ADMINISTRATIVE SHORT PLAT REPORT & DECISION

REPORT DATE:	October 15, 2014		
Project Name:	Limelite Short Plat		
Project Number:	LUA14-001083; SHPL-A		
Project Manager:	Kris Sorensen, Associate Planner		
Owner:	Virtuoso Ventura 6 LLC; 14508 NE 20 th St, #200; Bellevue WA 98007		
Applicant:	Todd Karam; Limelite Development; 14508 NE 20 th St, #200; Bellevue WA 98007		
Contact:	Andy McAndrews; GeoDimensions Inc; 10801 Main St Suite 200; Bellevue WA 98004		
Project Location:	16204 114 th Ave SE		
Project Summary:	The applicant is requesting administrative Short Plat review of an R-8 zone, 29,912 sf corner lot, to be subdivided into 5 single family residential lots. A storm water detention area would be located in the southwest corner of the site. Density would be 7.8 du/ac. The existing home would be demolished. Vehicle access to proposed lots would be from SE 162nd St and 114th Ave SE for Lots 1-4, and for Lot 5, there would be an easement across Lot 4 that provides connection to 114th Ave SE. Lot sizes range from 8,834 sf to 5,034 sf. Studies submitted include tree inventory, geotechnical report, technical information report with drainage information, and landscape analysis. Street

PROPOSED LOT LAYOUT

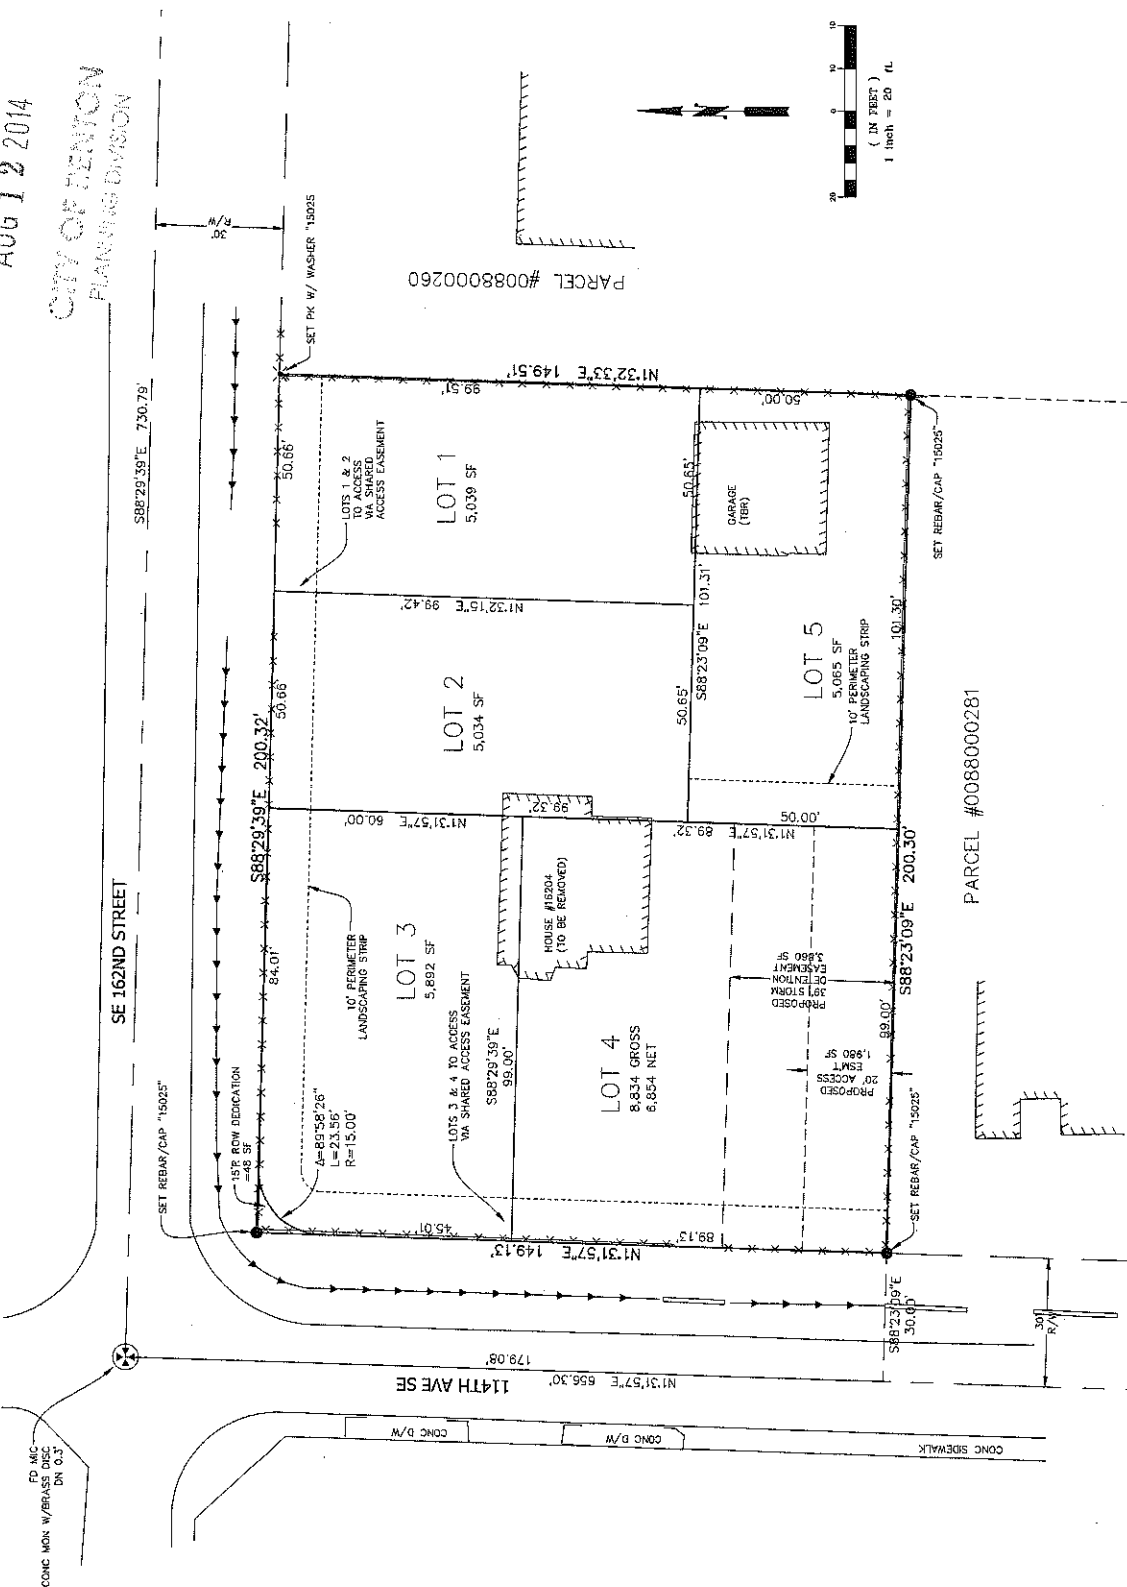
4. The corner lot, Lot 3, be required to have 25 percent openings of windows and/or doors on the facades facing public streets. .
5. The approved access points for the residential lots shall be as shown on the preliminary short plat layout submitted by GeoDimensions (Exhibit 3, titled "Proposed Lot Layout, Sheet 3 of 4, dated 7/30/14). In addition, the shared driveway access easements as shown on the GeoDimensions layout (Exhibit 3, titled "Proposed Lot Layout, Sheet 3 of 4, dated 7/30/14) shall be recorded on the face of the short plat.

6. All curb cuts shall be no closer than 50 feet from the northwest corner of the property where the SE 162nd St and 114th Ave SE streets intersect. A note to this effect shall be placed on the face of the short plat and shown on the construction engineering plans.

The proposed 20' Access Easement shown over the south 20' feet of Lot 4 does not agree with the grading and paving plan.
